DPC-NE-2003-A

DUKE POWER COMPANY  
OCONEE NUCLEAR STATION  
CORE THERMAL-HYDRAULIC METHODOLOGY  
USING VIPRE-01

Original Report: August 1988  
Approved Report: October 1989

Subject: Oconee Nuclear Station, Docket Numbers 50-269, -270, and -287  
Topical Report DPC-NE-2003, "Core Thermal-Hydraulic Methodology  
Using VIPRE-01"; Response To Request For Additional Information

FIGURE 1.

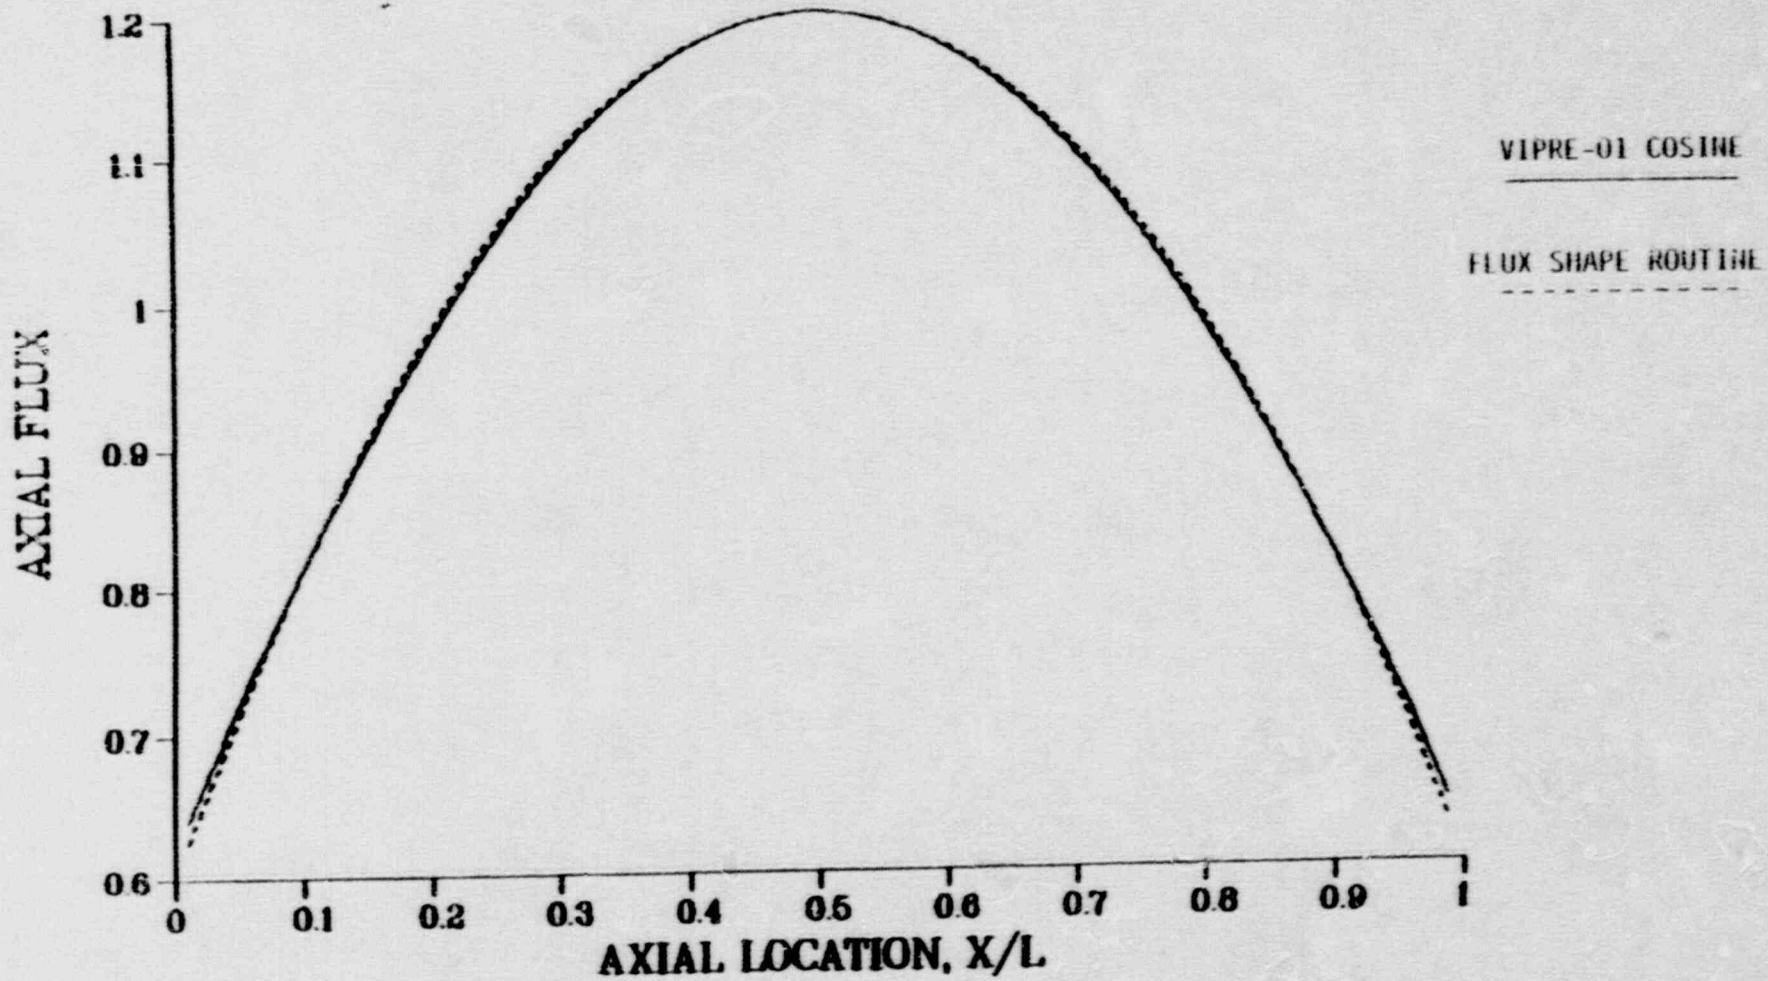
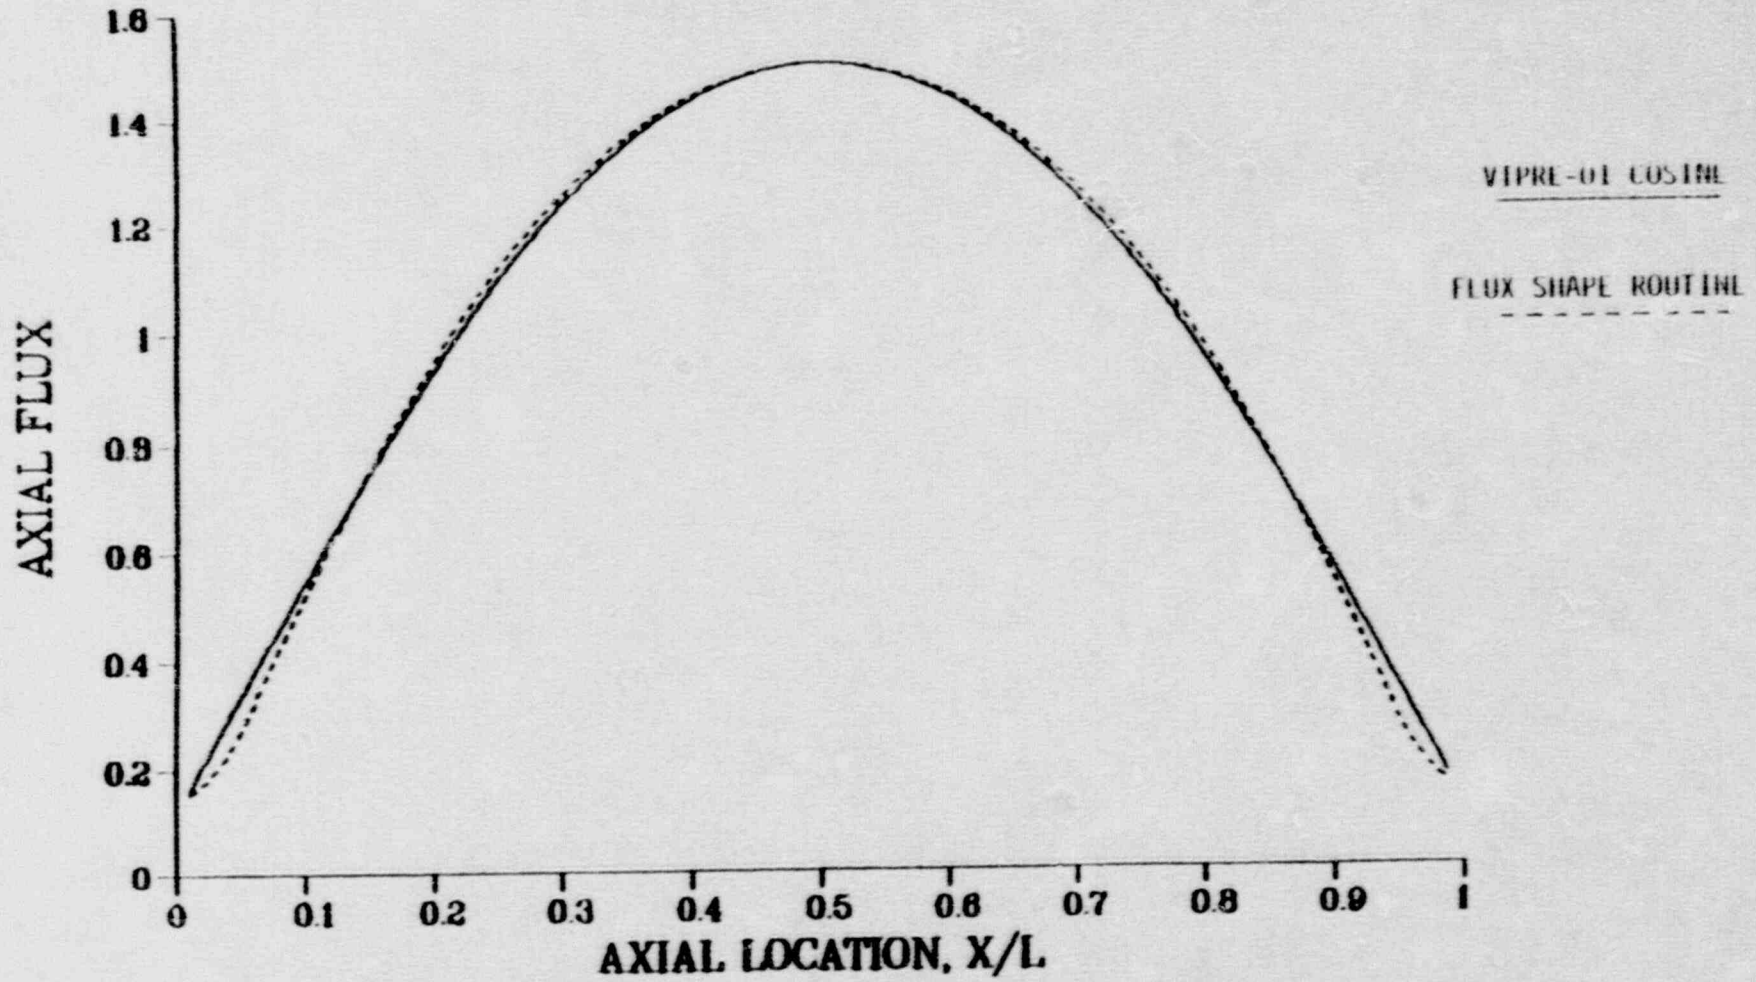
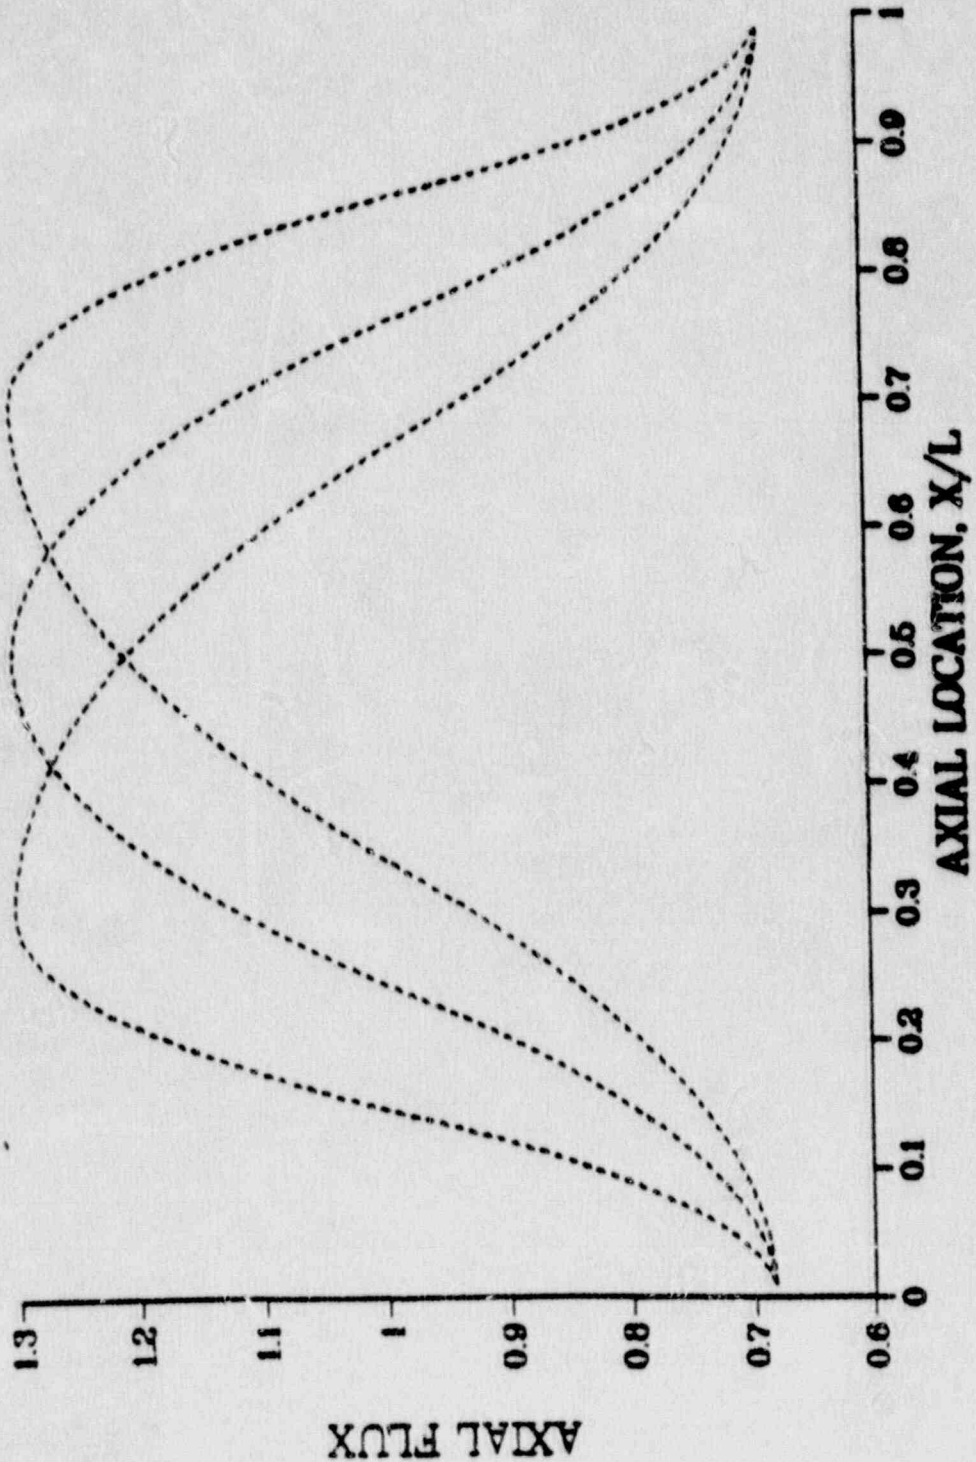
Section 5.10 states that a new routine is added to the VIPRE-01 code to generate axial power shapes with inlet, symmetric, or outlet peaks. Provide sufficient details of this routine.

The axial power shape routine added to VIPRE-01 is based on the following mathematical constraints on an axial power shape:

figures clearly show the agreement between the two methods of generating symmetric axial flux shapes. The new flux shape routine was added to generate skewed axial flux shapes. As discussed in Section 6.5 of the topical report, Maximum Allowable Peaking (MAP) limits are calculated for a range of axial peaks with the location of the peak varied from the bottom to the top of the core. As an example of the flux shapes used to calculate the MAP limits, three axial shapes are shown in Figure 3 for an axial peak of 1.3 at  $X/L = 0.3, 0.5, \text{ and } 0.7$ .
